ADDENDUM

Project: Spring Creek 2,4,7

Project No.: 516102918020101 Addendum No.: 1

Date: July 17, 2018

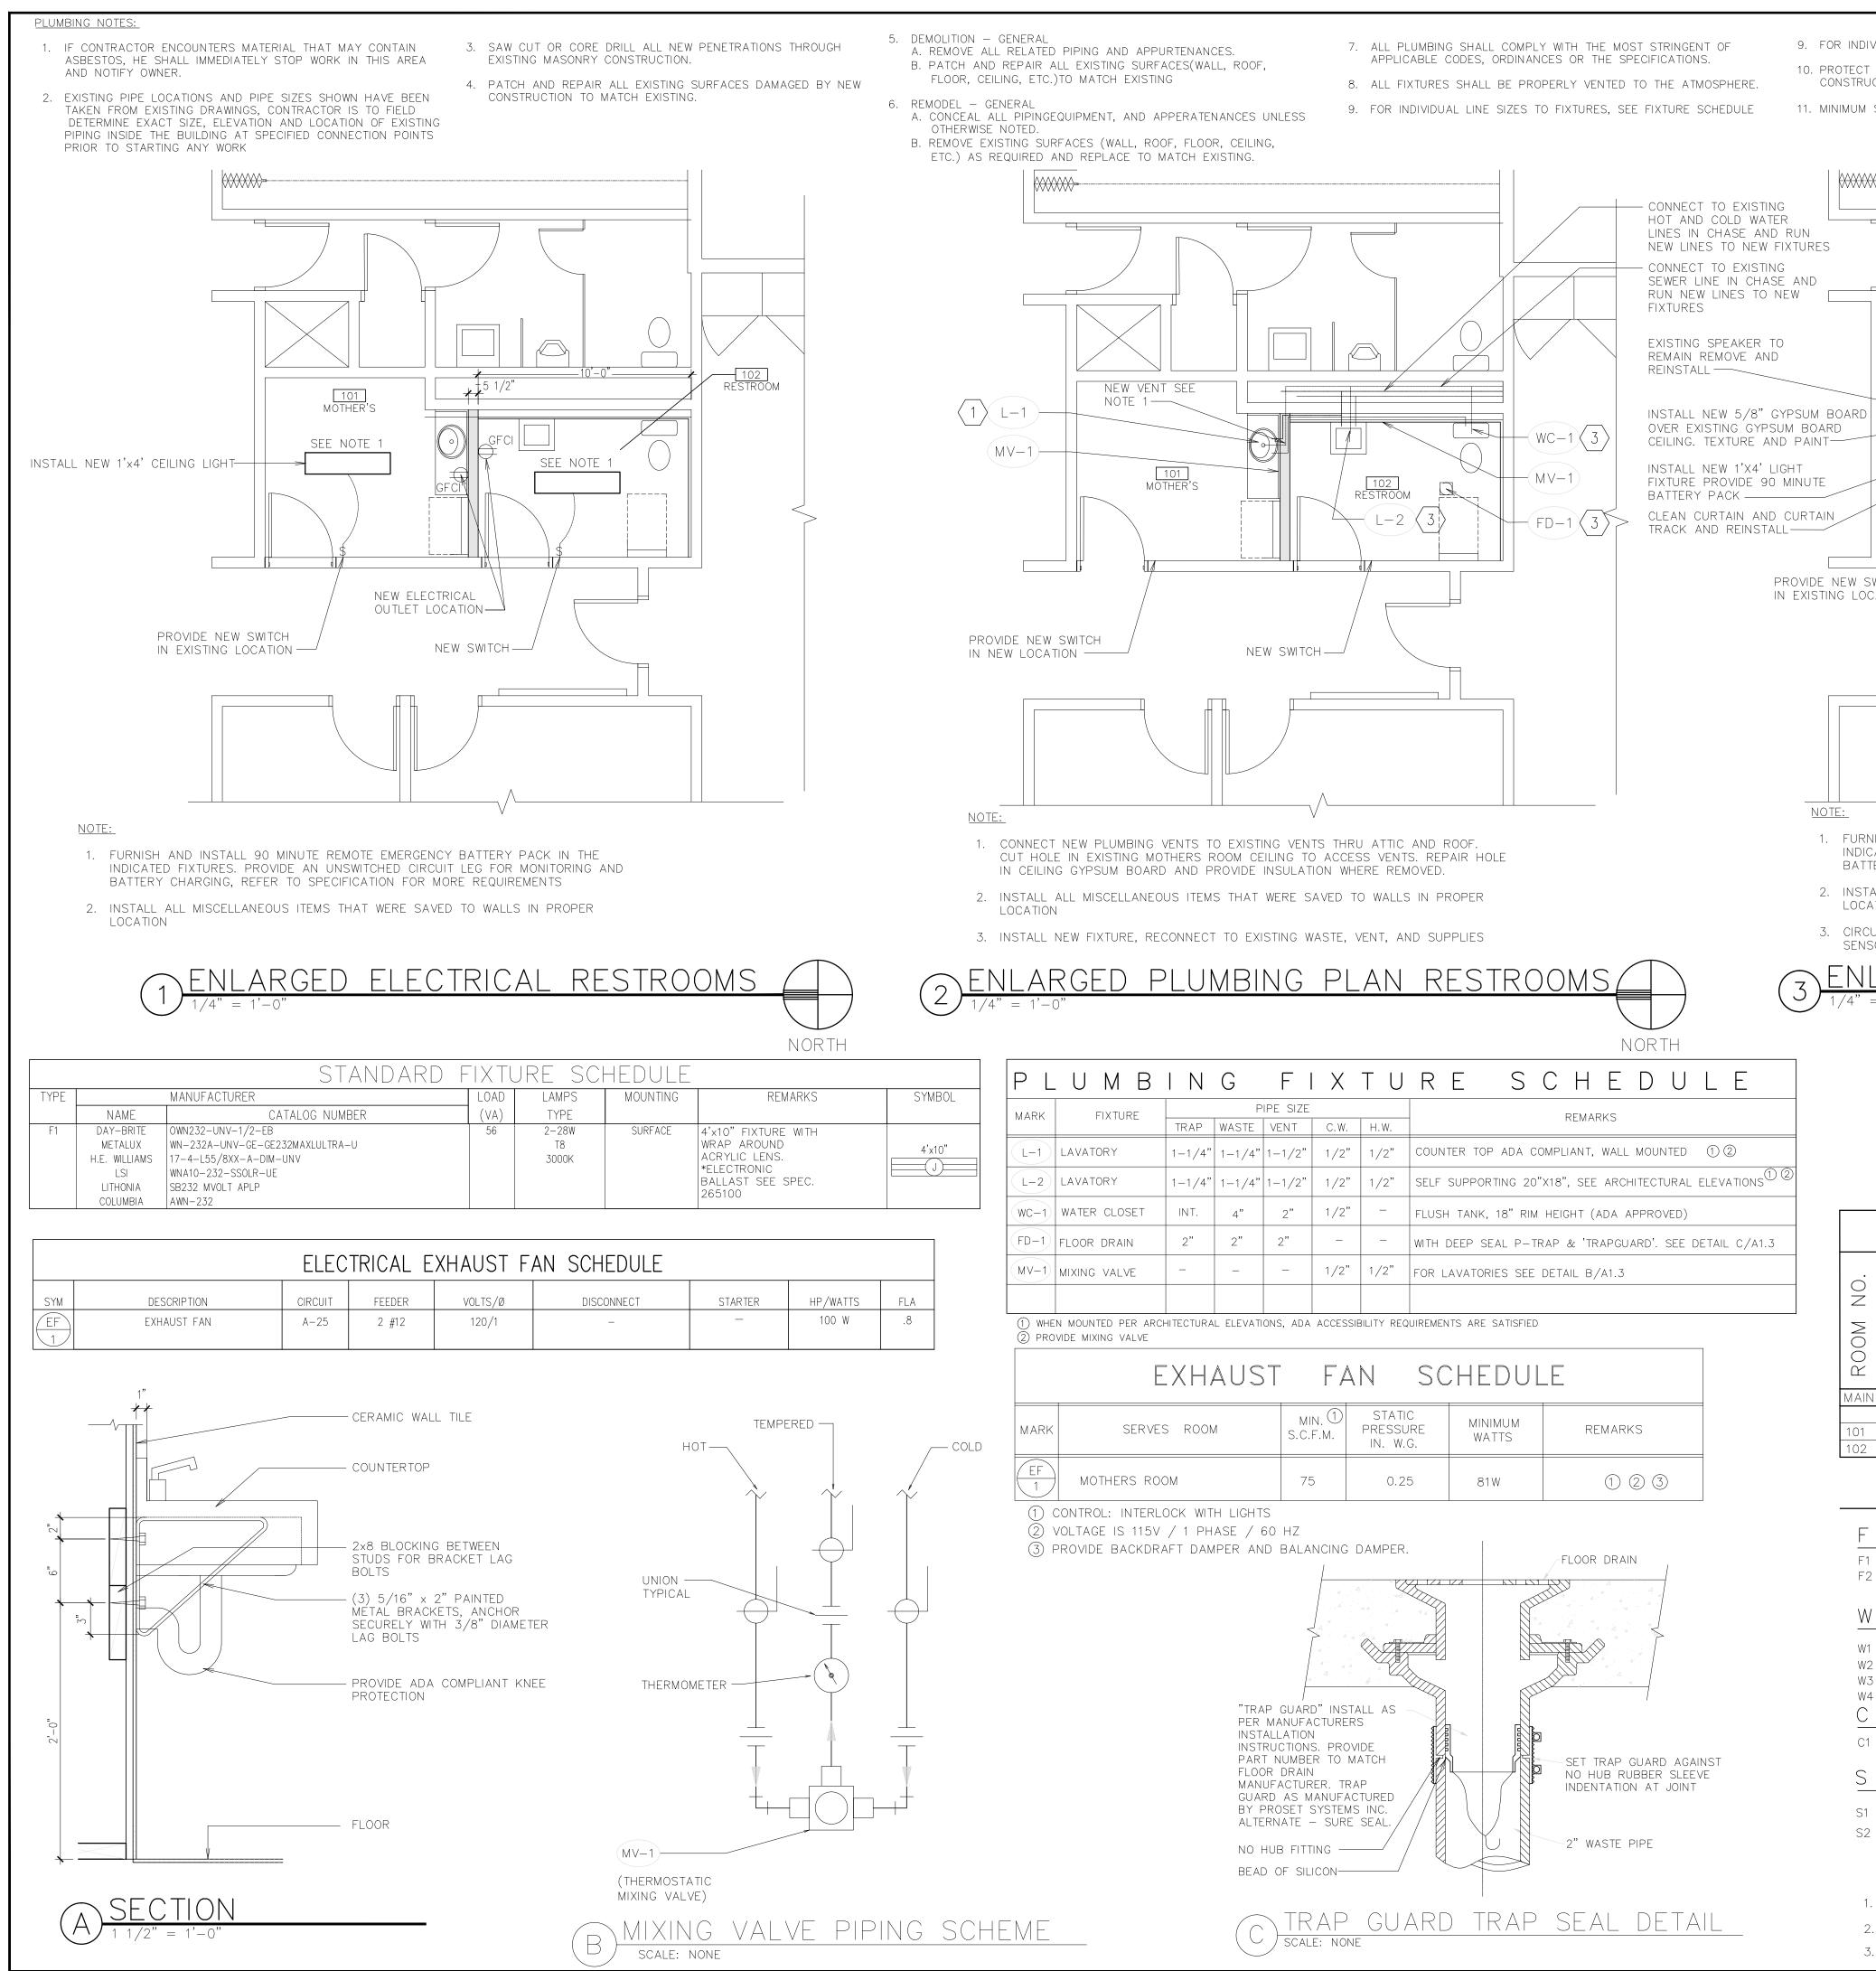
b. Delete Sheet A1.3 and replace with the attached Sheet A1.3.
